Commercial & Industrial Air Compressors

California Energy Commission 45-Day Language

Developed by Energy Solutions
on behalf of the California IOUs

CASE TEAM COMMENTS ON 45-DAY LANGUAGE

TSL 3 is Cost Effective for Rotary Compressors

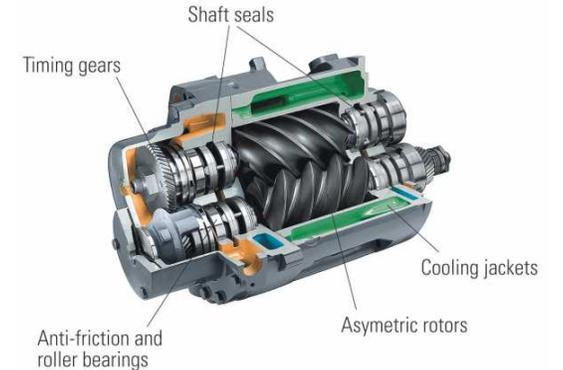
Though the CASE Team supports the Energy Commission moving forward with energy conservation standards for air compressors, we note that our proposal for TSL 3 is cost effective and delivers greater energy savings.

- DOE selected TSL 2, the Energy Commission has aligned with DOE's proposal
- Compared to the Energy Commission's proposal, our proposal would have resulted in 223 GWh/yr more of stock energy savings after stock turnover, 36,507 MTCO₂e/yr more stock GHG emissions reductions after stock turnover, and is still cost-effective

DOE Has Already Addressed Manufacturer Concerns

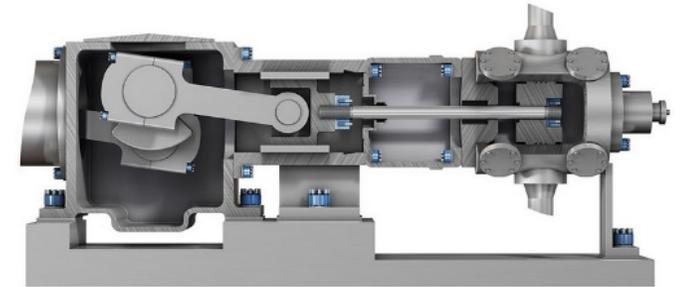
The Department of Energy addressed manufacturer concerns by changing the energy use analysis between its NOPR and final rule stages. Specifically, DOE altered its annual operating hours (AOH) distribution to better align with manufacturer recommendations.

- In response to DOE's May 2016 NOPR, manufacturers pointed to what they perceived as flaws in DOE's analysis. In particular, compressor AOH was criticized
- In its pre-published Final Rule, DOE adjusted the AOH to account for data provided by manufacturers
- Evidence of this change is shown in the annual energy consumption of fixed-speed air-cooled rotary compressors, which declined by 18% between the NOPR and Final Rule analysis. Annual energy consumption directly arises from AOH
- This is evidence that issues from the NOPR have been addressed by DOE
